Sienna Construction Note 1/3/2010

Transmitter power loss

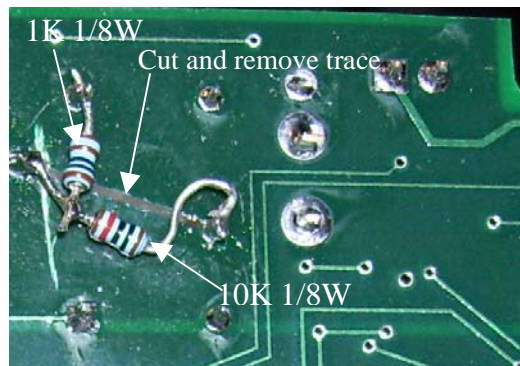
Problem: In CW and FM modes, the transmitter gradually loses power.

Cause: A hardware problem on the Tx board causes the relay that switches between CW/FM and AM/SSB not to switch, causing the local oscillator not to feed into the CW/FM waveshaping circuit except via stray capacitance.

Fix: Add three resistors to the board and cut one trace, as follows:

- Cut the trace going from relay K12 pin 10 to the gate of Q21. This trace is on the back of the board. Remove the TxBPF board first to provide access to this area of the board. After cutting the trace, peel the entire trace off the board. See picture below.
- On the back of the board, solder a 10K 1/8W resistor in place of the trace you just cut. See picture below.
- Also on the back of the board, solder a 1K 1/8W resistor between the gate of Q21 and pin 1 (ground) of relay K12. See picture below.

- Solder a 1K 1/8W resistor between pin 3 of Q25 (a 6-pin SMT device) and the emitter of Q19 (VCC). VCC is also available on pin 1 of Q25. See picture below.
